DAUPHIN COUNTY SUBDIVISION/LAND DEVELOPMENT REVIEW REPORT

Plat Title Preliminary/Final Lot Add-On Plan for Richard H. & Nancy H. Seachrist

Project Description: To consolidate 2 existing tracts of land.

PRELIMINARY/FINAL LOT ADD-ON PLAN

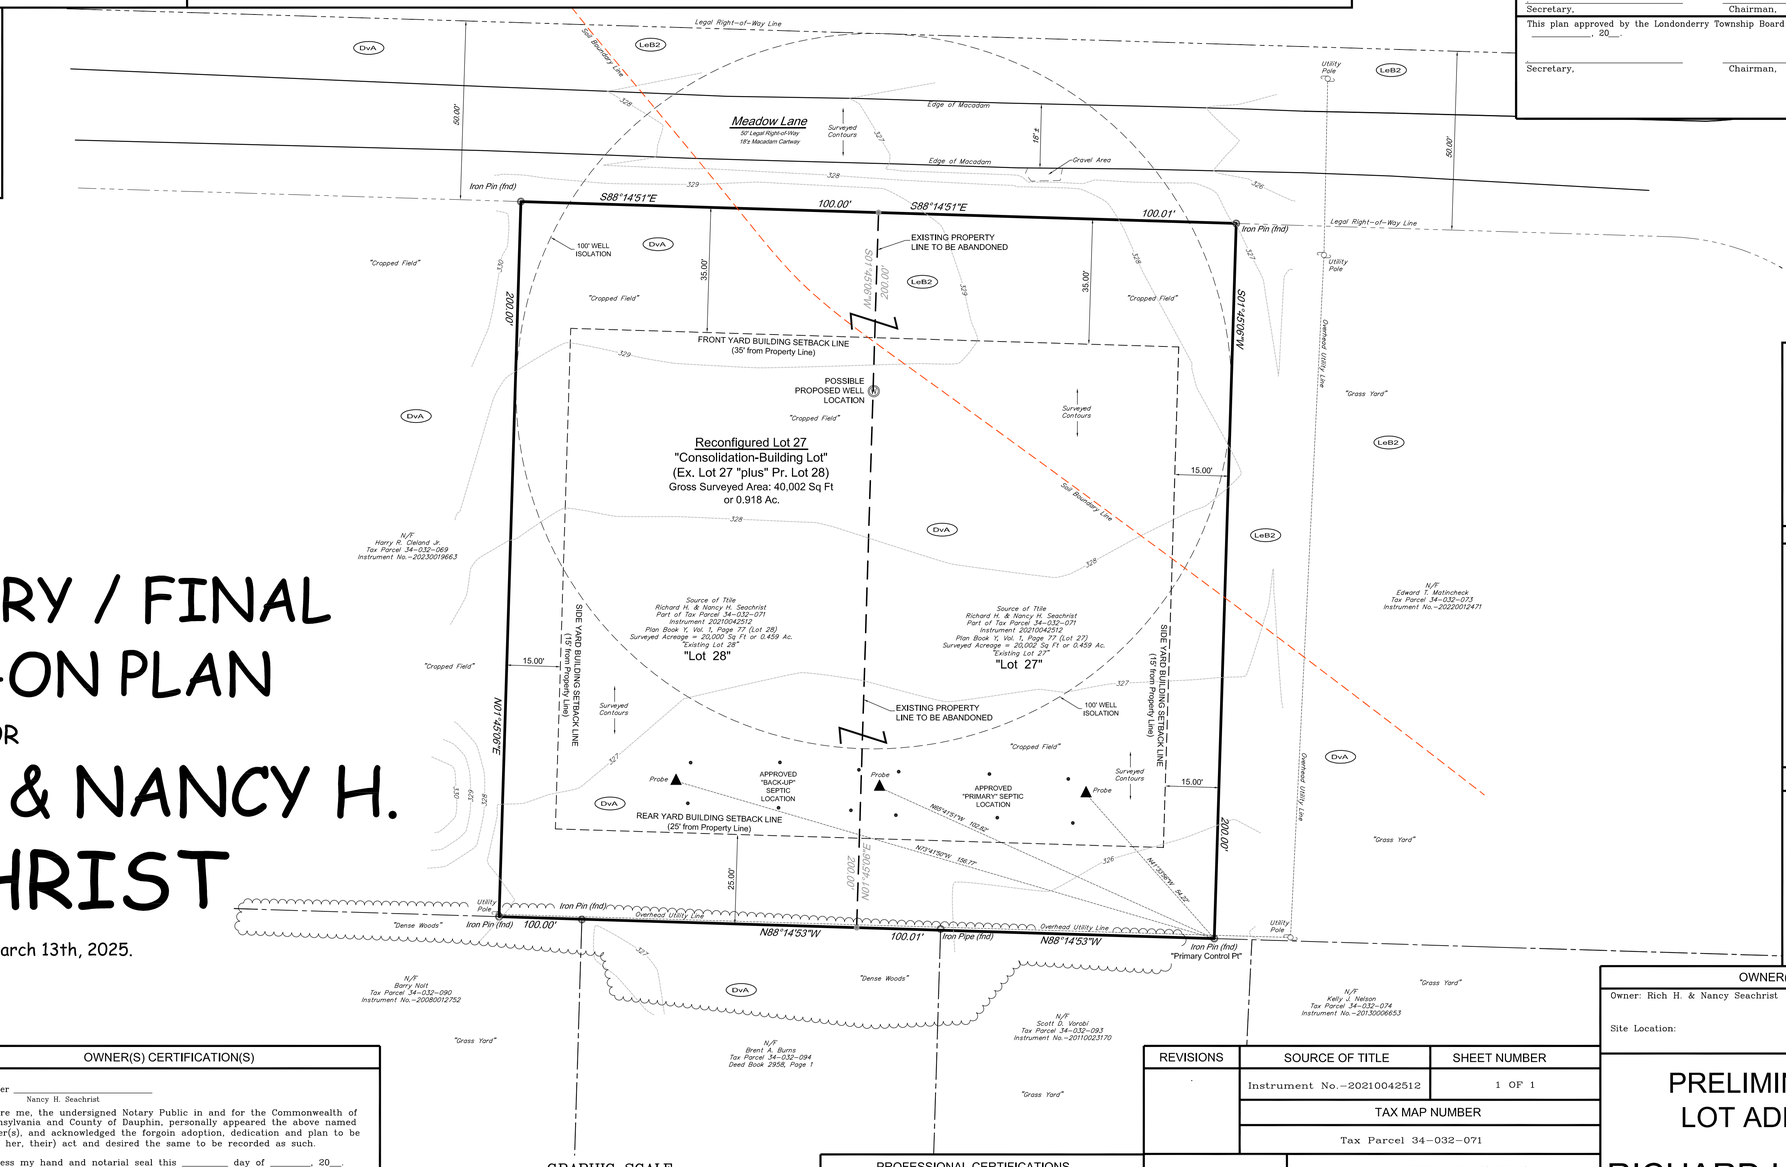
1. All certifications, notarizations, and signatures must be obtained before the plan is brought in for signing. Provide dedicatory statement (22-312.1.A.6) to the cover sheet.

2. The consolidated lot is under the 1-acre area requirement established in Section 604 (Area Regulations) of the Zoning Ordinance.

3. Is a waiver or deferral being requested for Sections 22-506 (Sidewalks) and 22-507 (Curbs and Gutters)?

4. Verify the location of any known easements or protective covenants.

5. The Dauphin County Planning Commission application for plan review notes that one (1) dwelling unit is to be constructed as part of the plan. The applicant should note that before a building permit is issued the requirements of Part 6 (Residential Districts – Single Family-Country) including building height and overall lot coverage must be verified.
